Re: Boat Lifts at the Ocean Springs Harbor

SECTION 00901-02
ADDENDUM NO. 2

Project:	Owner:	Engineer's Project No.:
Boat Lifts at the Ocean Springs Harbor	Mississippi Department of Marine Resources	216-015

S2.2
SHEET OF

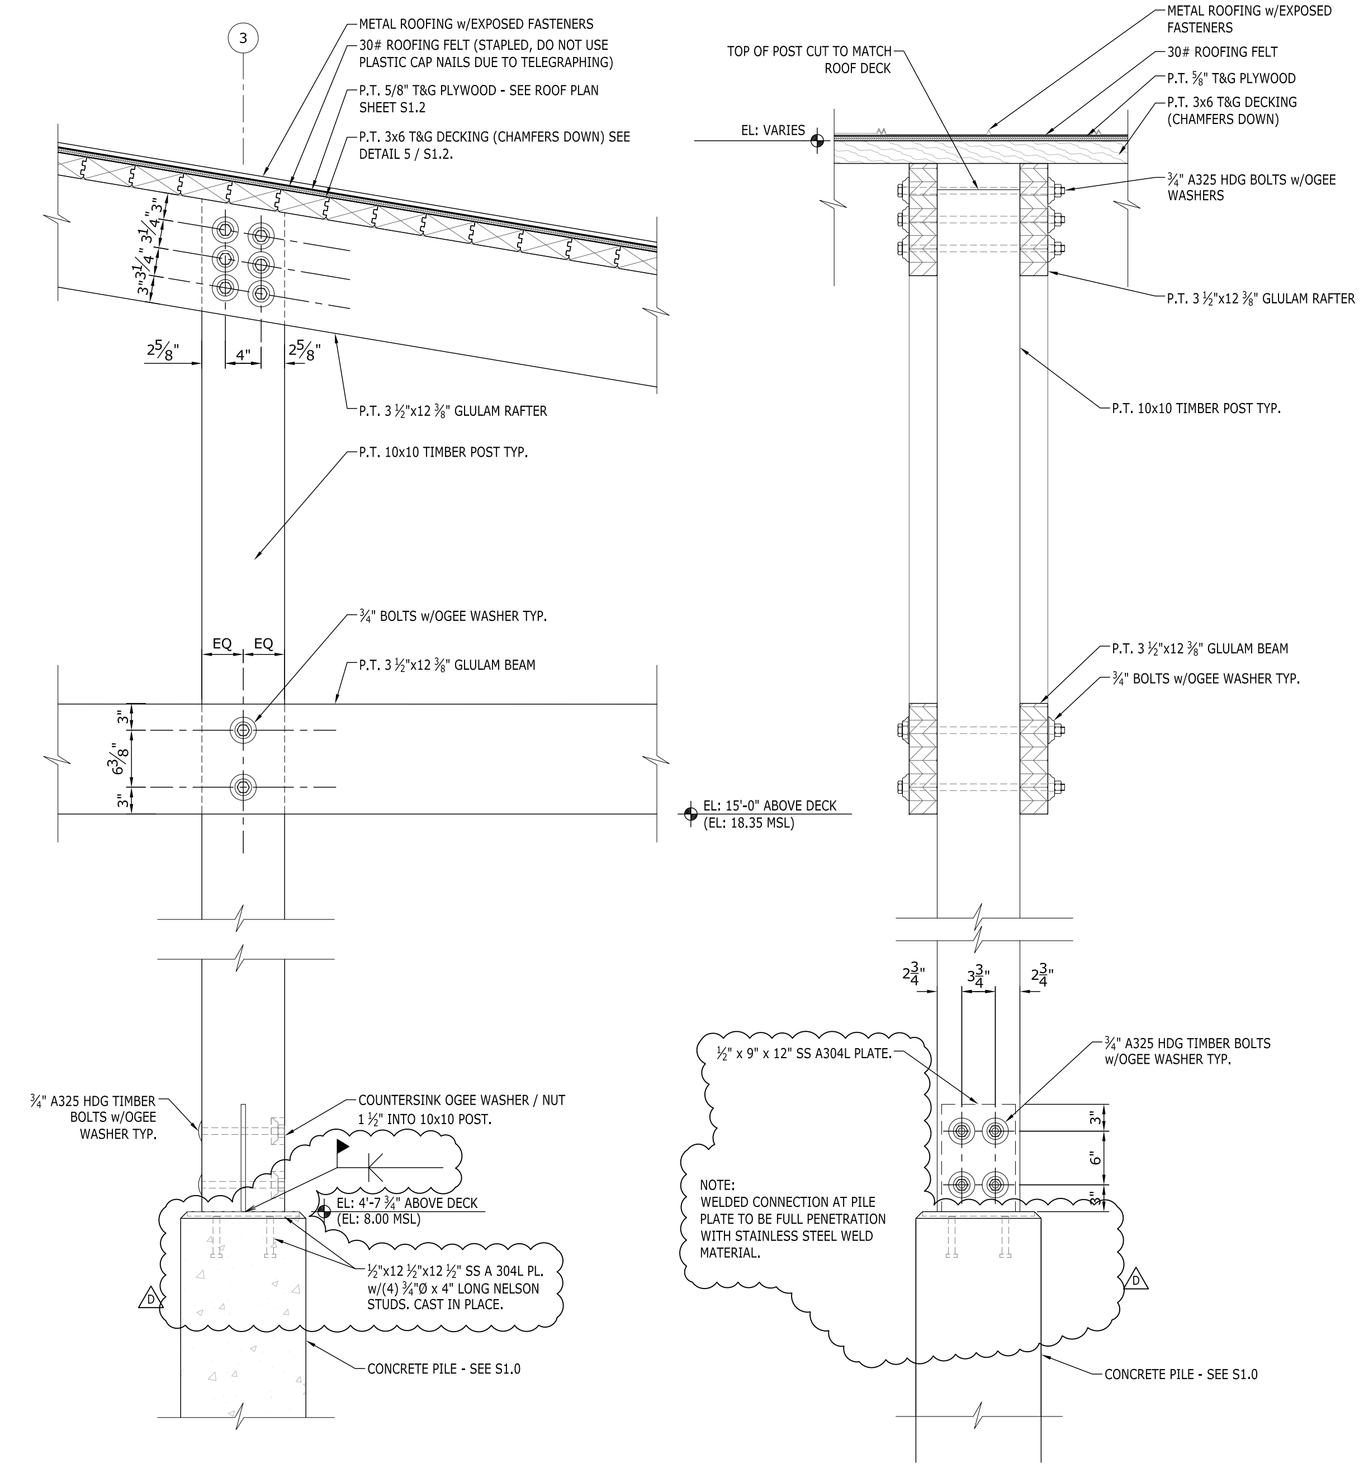
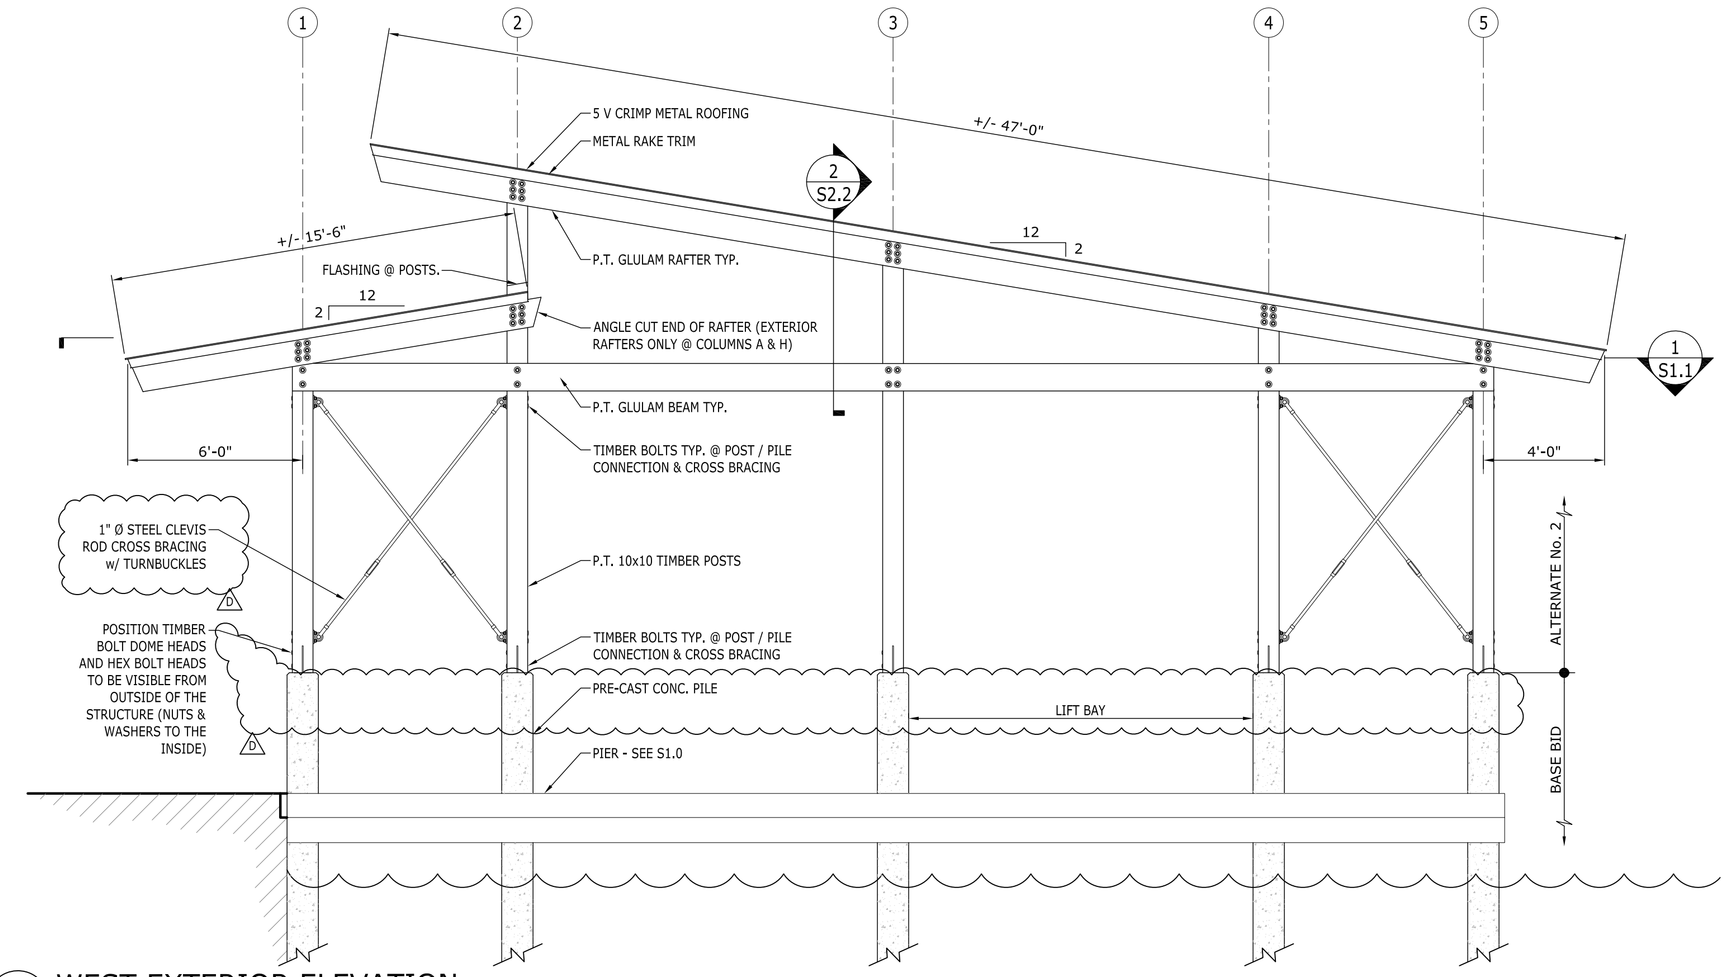
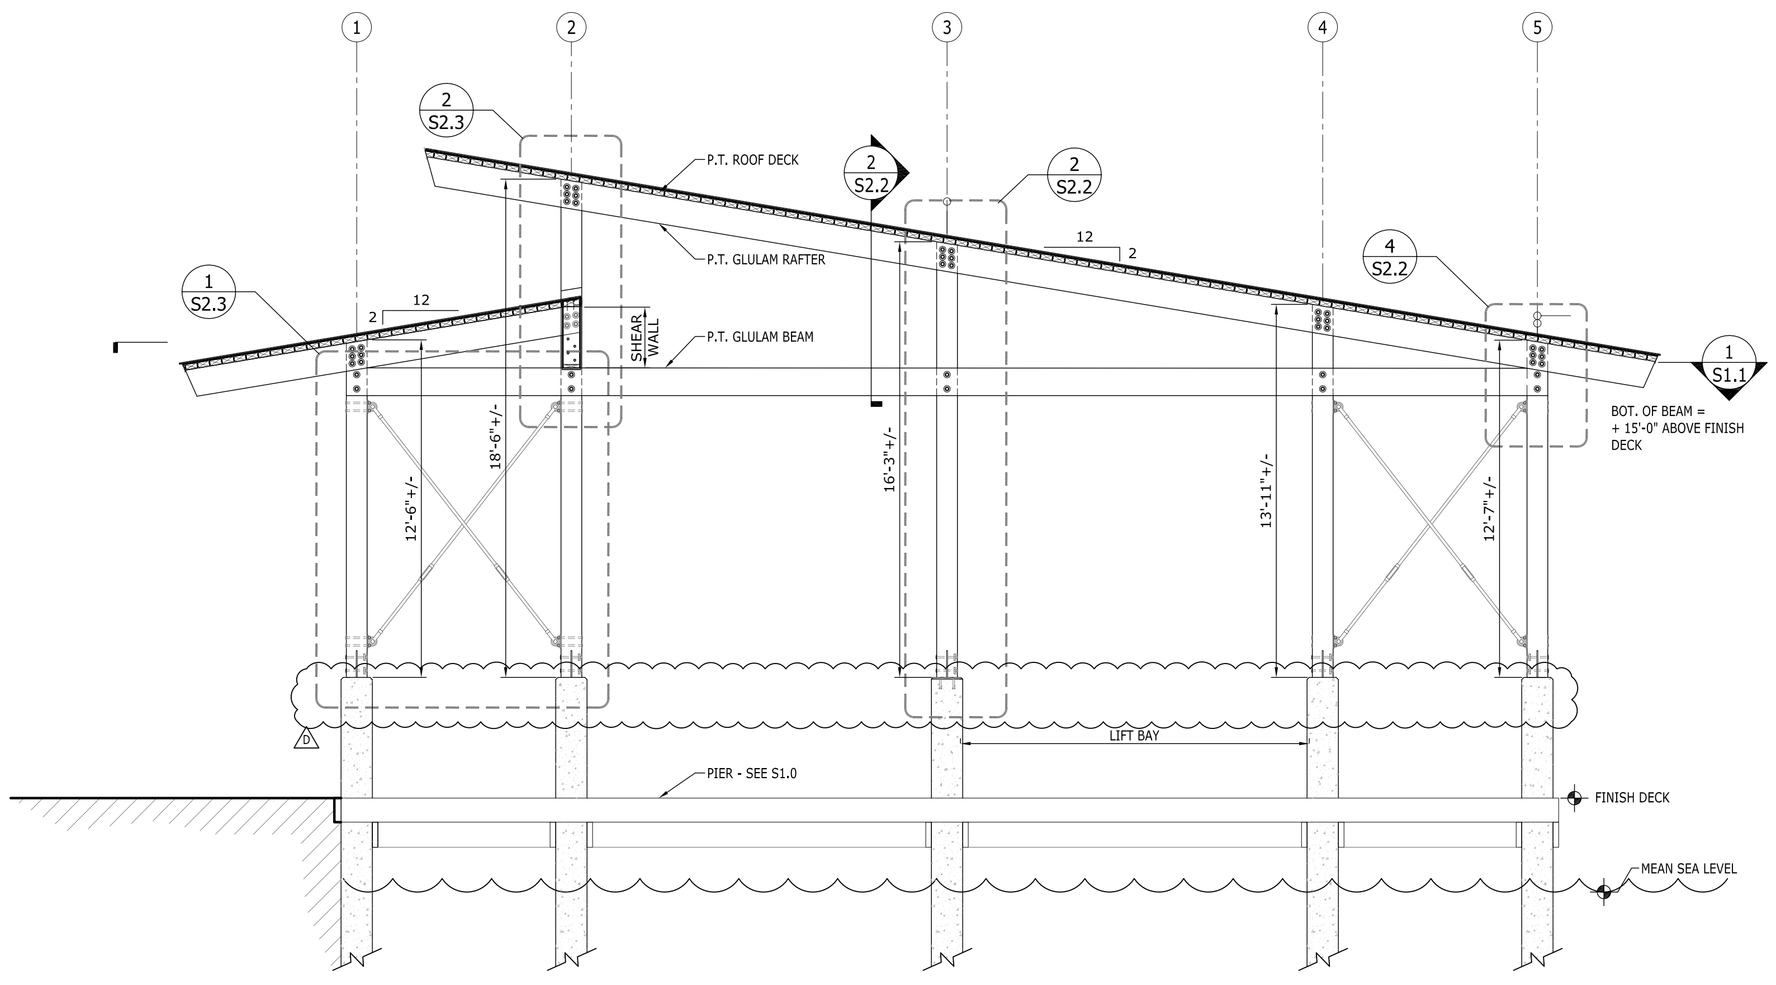
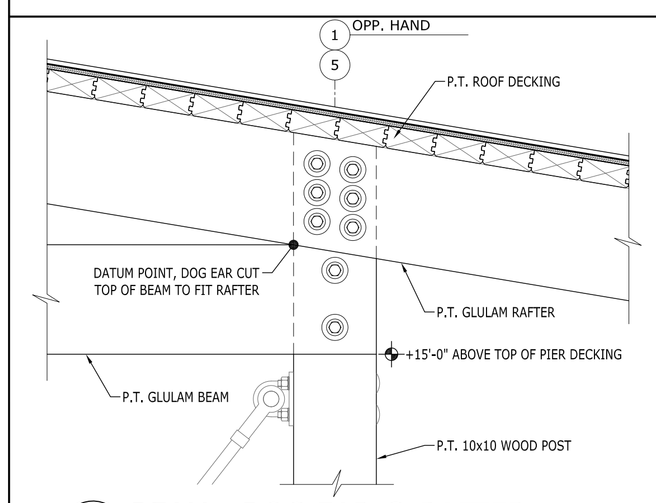
Delete Sheet S2.2 in the project manual and replace with **Attachment #1 to Addendum #2.**
   Notable Changes:
   a. Pile top plate is to be cast in place with Nelson Studs.
   b. Weld column plate to pile plate after driving piles.
   c. Cross-brace rods are to 1 inch diameter.
2. SHEET S3.1

S3.1
SHEET OF

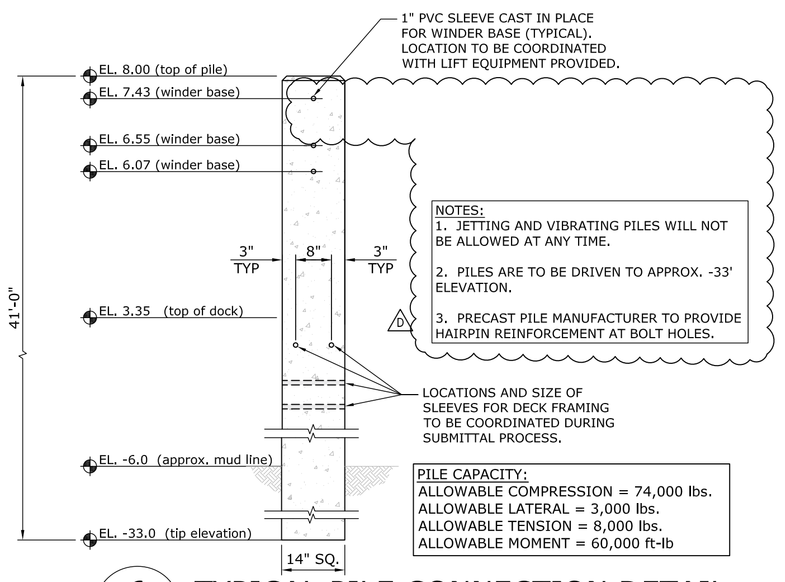
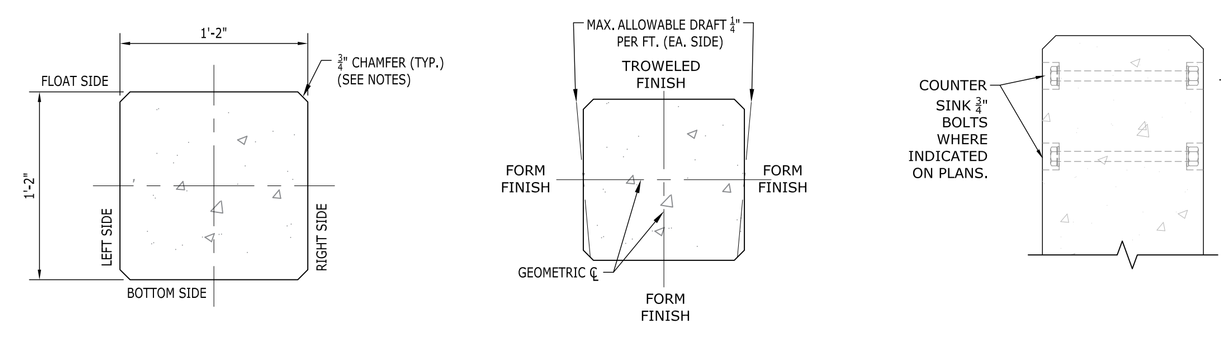
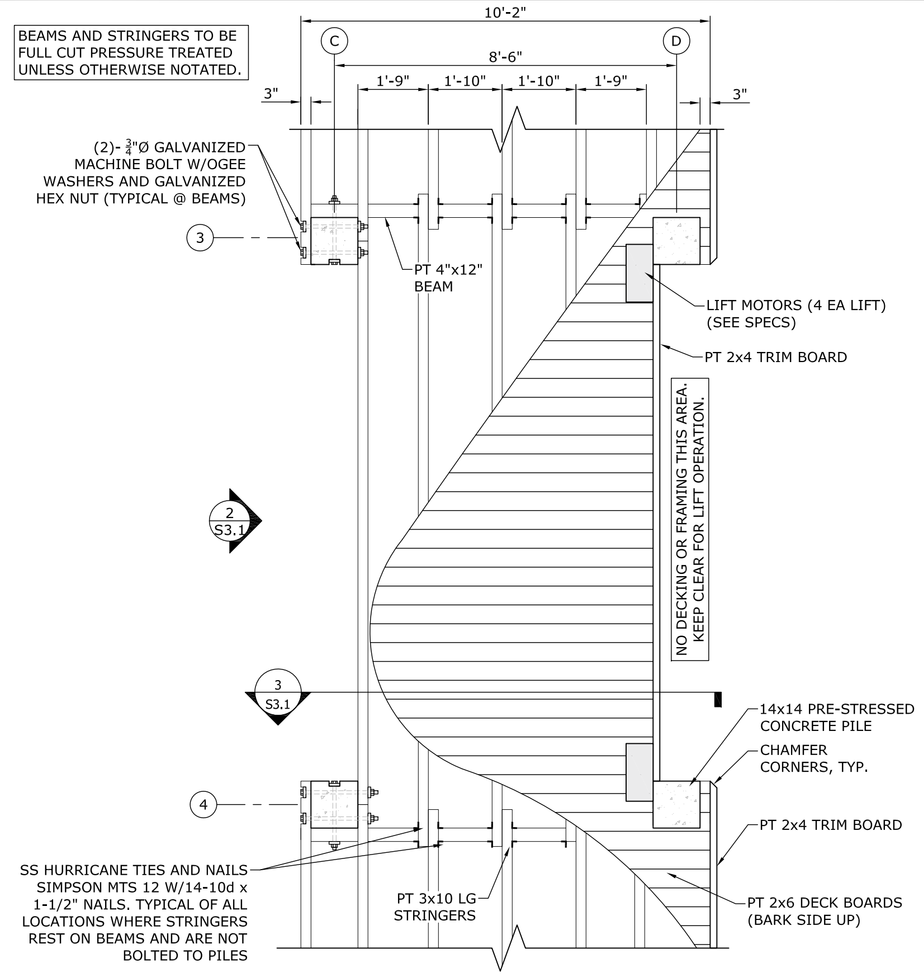
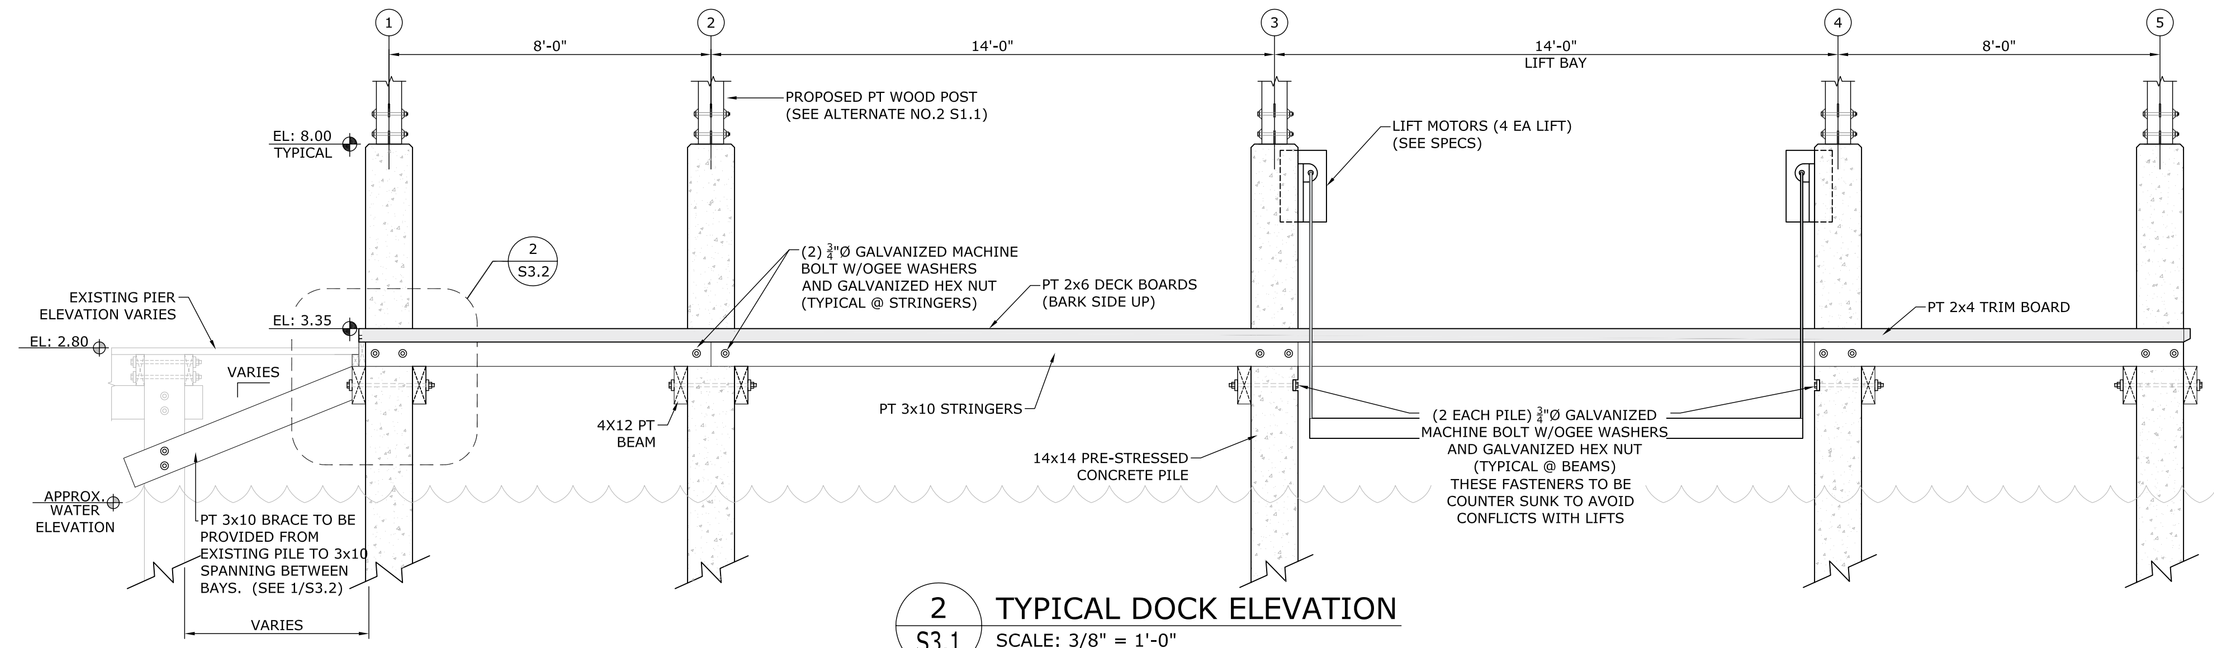
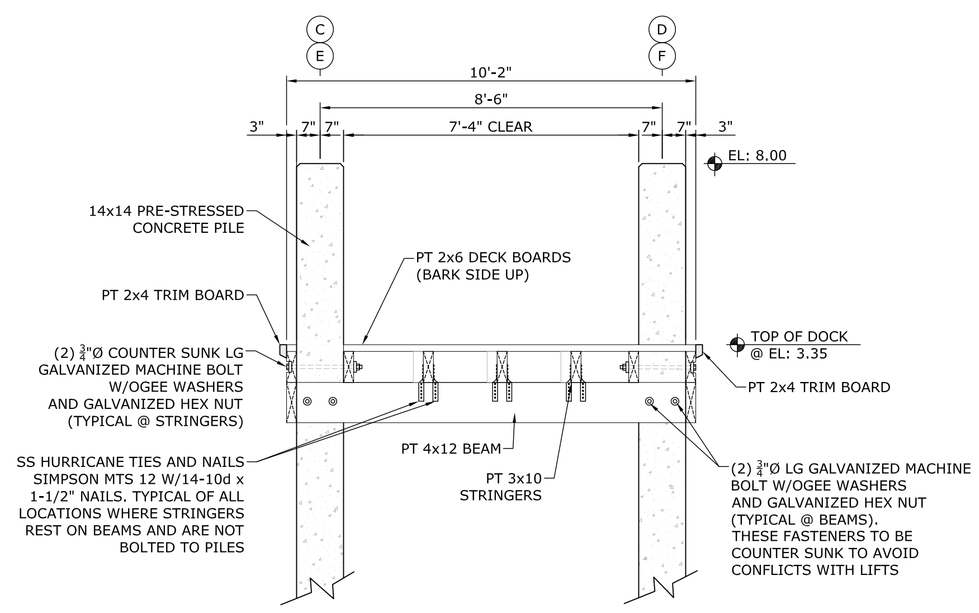
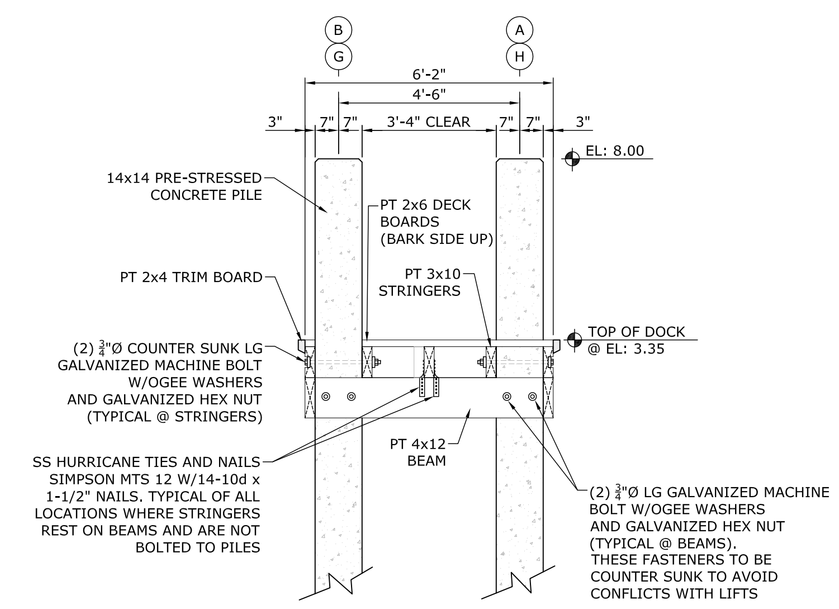
Delete Sheet S3.1 in the project manual and replace with **Attachment #2 to Addendum #2.**
   Notable Changes:
   a. Pile load tests will not be performed.
